1 Albany Terrace

Design & Access Statement
35_Listed Building Consent

1 Albany Terrace
London
NW1 4DS

Image of existing, strengthened joists

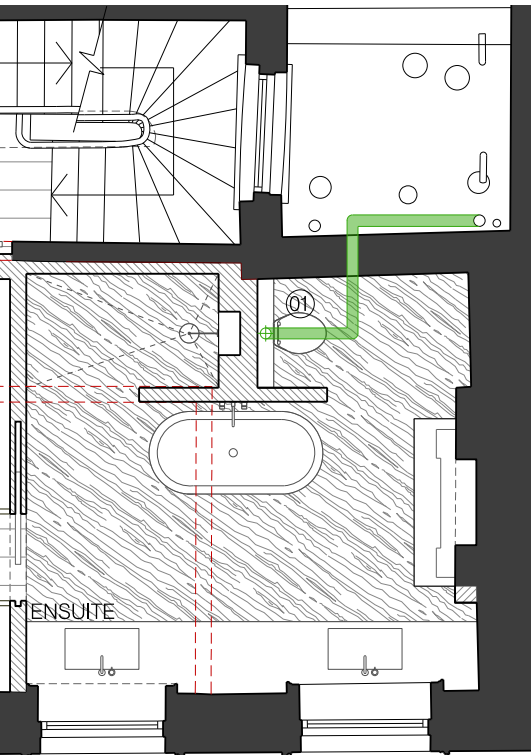
Thanks for sending through that photograph of the joists.

I think at this stage it appears that Option 2 would require less invasive works and associated harm to fabric and we can proceed with formally assessing that approach.

SVP Plan Route:
Option 2

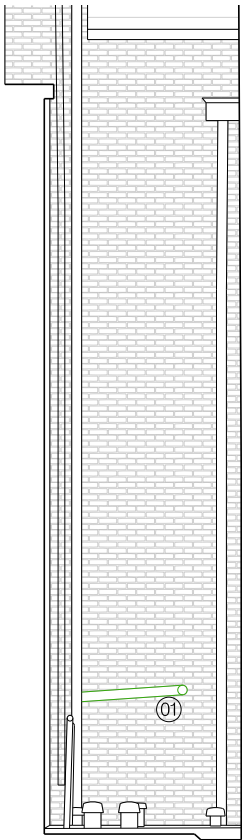
As rerouting/installation of the new SVP would involve the loss of external fabric, in order to formally regularise the works (removal of external brickwork, addition of pipework infrastructure clutter etc.) LBC will be required. Unfortunately, I cannot vary the previously approved drawings and including the additional works under the current application would require a change in the Development Description and re-consultation. It may therefore be easier just to submit a new LBC.
